London Luton Airport Expansion

8.68 Applicant's response to Written Questions - Biodiversity

**8.68 APPLICANT'S RESPONSE TO WRITTEN QUESTIONS -
BIODIVERSITY**

Deadline:	Deadline 5
Planning Inspectorate Scheme Reference:	TR020001
Document Reference:	TR020001/APP/8.68
Author:	Luton Rising

Drawing Title
 Applicant's Response to ExA Written Question BIO.1.3:
 Modelled ecological receptors (nitrogen deposition results)
 Assessment Phase 1
 Page 2 of 2

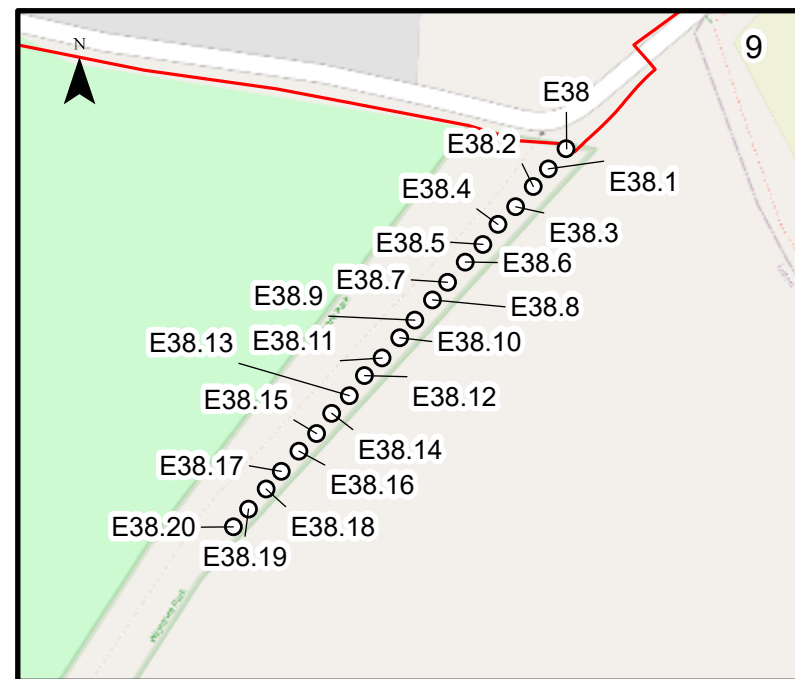
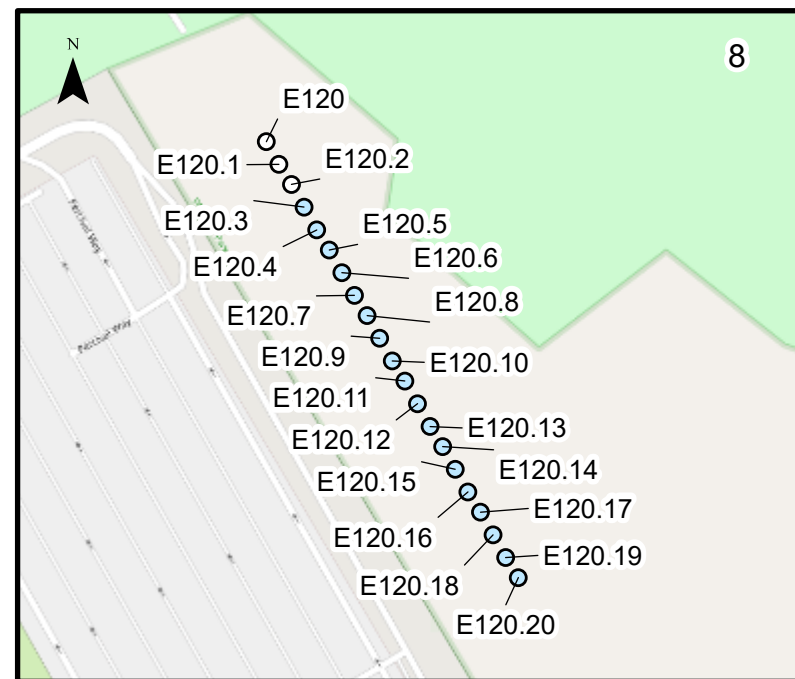
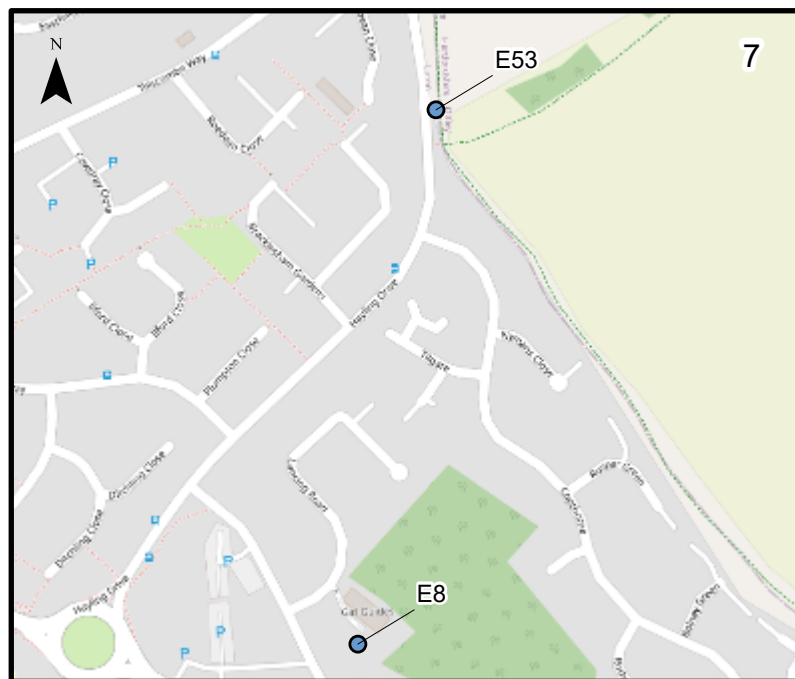
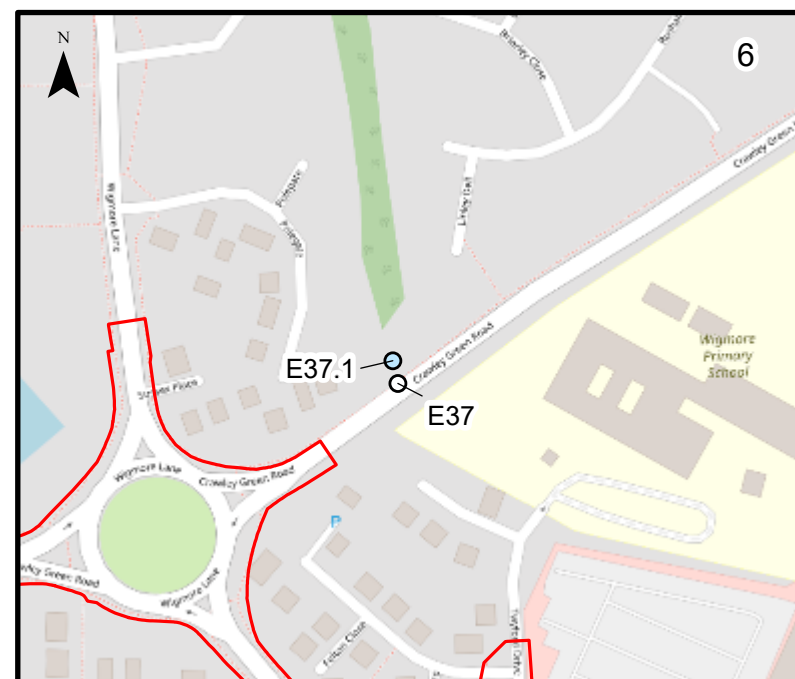
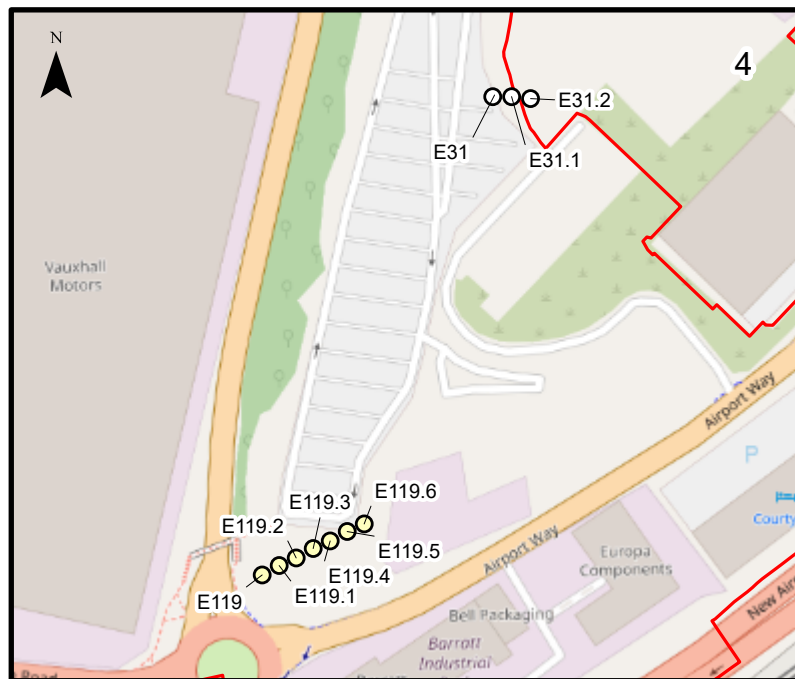
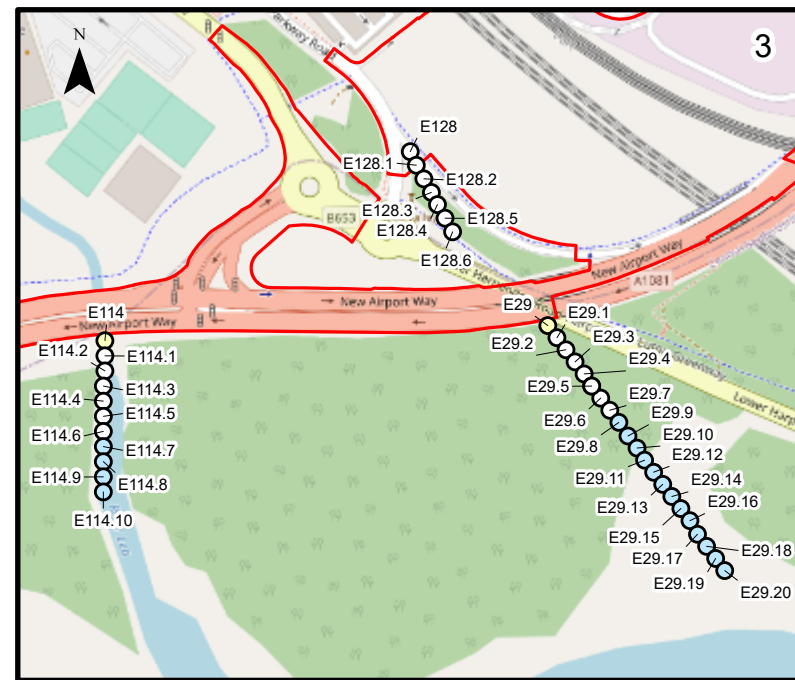
BIO.1.3	<p>Question: Nitrogen deposition At ISH6 and in the Applicant's response at Deadline 3 [REP3-053, paragraph 3.1.19] it is stated that agriculture is a significant source of nitrogen and that the proposed removal of land from agricultural production would counterbalance the modelled nitrogen deposition on protected habitats and species.</p> <ol style="list-style-type: none"> 1. Provide an assessment, ideally quantitative, of the anticipated reduction in nitrogen deposition from removal of agriculture and the associated timescales for this. 2. Provide the equivalent assessment of the anticipated reduction in nitrogen deposition from the shift to electric vehicles referred to in [REP3-053, paragraph 3.1.21]. <p>The results of the air quality modelling in Appendix 7.3 [APP-063] and mapping of these [AS-099] are noted. However, the plans are not clear in respect of ecological receptors because cross-referencing is still required with the results tables. Please provide clear illustrations for the different phases of modelling of:</p>

PINS ID	Question / Response
	<p>3. Exceedances of the mean NOx critical level and contribution of the Proposed Development to this, highlighting where it is more than 1% [APP-053, Table 3.37].</p> <p>4. Exceedances of a 1% increase in nitrogen deposition and the change against the lower critical load [APP-053, Table 3.38].</p> <p>5. These should be provided on a background map and scale to clearly illustrate the effects on identified ecological receptors.</p> <p>Table 3.3 [AS-028] sets out the location of sensitive ecological receptors, including transect locations, which are illustrated in Figure 7.3b [AS-099]. It is noted that transects are not shown for (at least) receptors E10, 31, 37, 39, 48, 63, 64, 65, 114, 119, 120 and 121. Receptor locations and transect locations are missing for (at least) E123, 124, 125, 127, 128 and 129.</p> <p>6. Provide an updated Figure 7.3b showing the location of missing receptors/ transects and confirm that no other receptor locations are missing. Transect sub-numbering e.g. E120.x should also be provided.</p> <p>Response: Question 1</p> <p>For clarity, the Applicant did not say that removing land from agricultural production would counter-balance the impacts of the Proposed Development, if 'counterbalance' is interpreted as meaning 'entirely offset'. At ISH6 the Applicant stated that they did not believe the benefit of the removal of land from agricultural production could be quantified (hence no quantification is presented in Chapter 8 of the ES [AS-027]). However, the Applicant noted (in ISH6 and in the ISH6 Post Hearing Submission [REP3-053] and in Chapter 8 of the ES [AS-027]) that agriculture is a significant source of atmospheric nitrogen at all the modelled sites. This can be verified by using the Site Relevant Critical Load App on the APIS website (https://www.apis.ac.uk/app), entering the coordinates for each designated site, selecting 'results' on the left hand menu and then selecting the 'source attribution' tab and the 'local contributions to nitrogen deposition' pie chart. As examples:</p> <ul style="list-style-type: none"> • 29.2% of background nitrogen deposited in the 5km grid square in which Winch Hill Wood is situated derives from agriculture (livestock and fertiliser), compared to 36% from transport (road transport and 'other transport' i.e. the airport and the railway); • 21.6% of background nitrogen deposited in the 5km grid squares in which Burnt Wood, Stubbocks Wood, and Diamondend Springs, Limekiln Wood & Pondcroft are situated derives from agriculture, compared to 25.3% from transport;

Drawing Title
Applicant's Response to ExA Written Question BIO.1.3:
Ecological Transects
Page 1 of 3

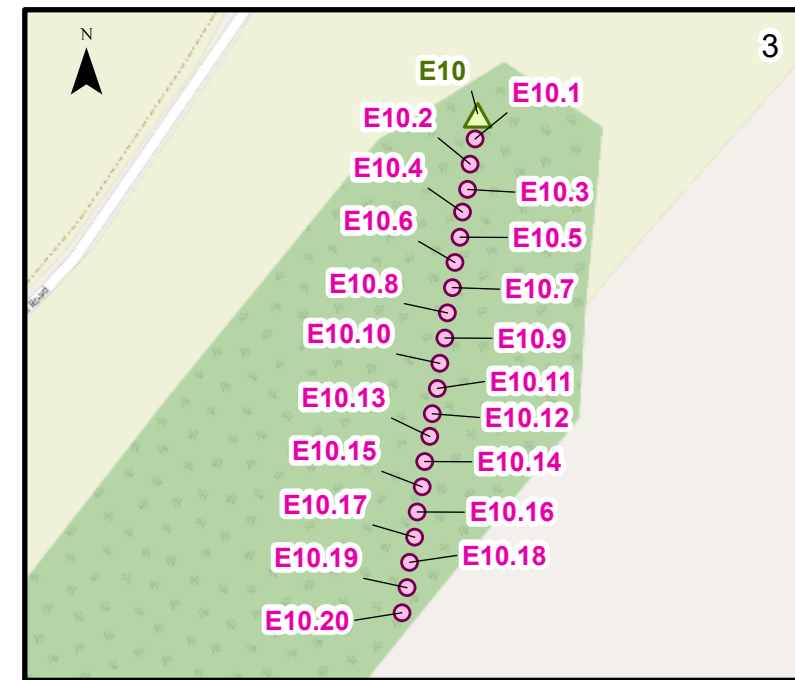
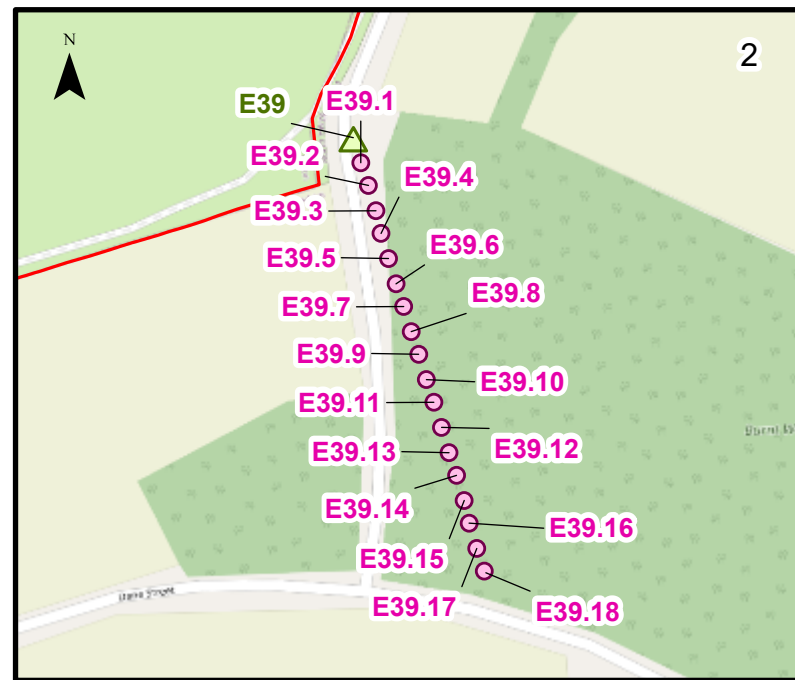
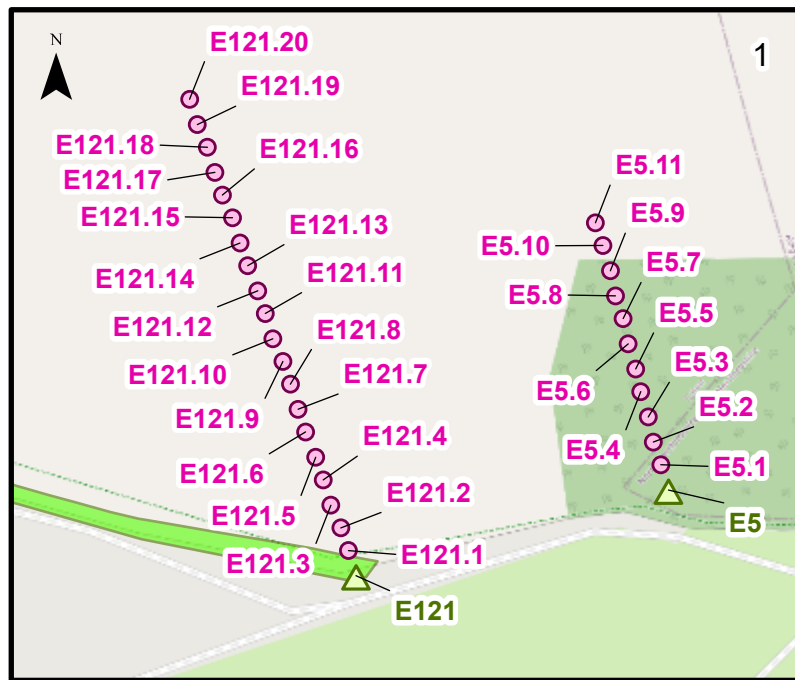
PINS ID	Question / Response
	<p>It is important to consider the effect from traffic will be different at each ecological site depending on the change in vehicle emissions associated with the Proposed Development, the distance to roads and the key sources of pollutants at each site. Therefore, the change in NOx emissions at each ecological site, as a result of the reductions in road emissions demonstrated in the above figures will not be equal at each location, but would still be beneficial compared to the values presented in the ES (Appendix 7.3 Air Quality Results [APP-063]).</p> <p>Questions 3-6</p> <p>In response to points 3 to 6, for clarity additional figures (rather than updates to existing) have been produced and are provided in Appendix B to this document. It is noted that Figure 7.3b [AS-099] did include the receptors being flagged as missing. The original Figure 7.3b [APP-148] was missing those sites..</p>
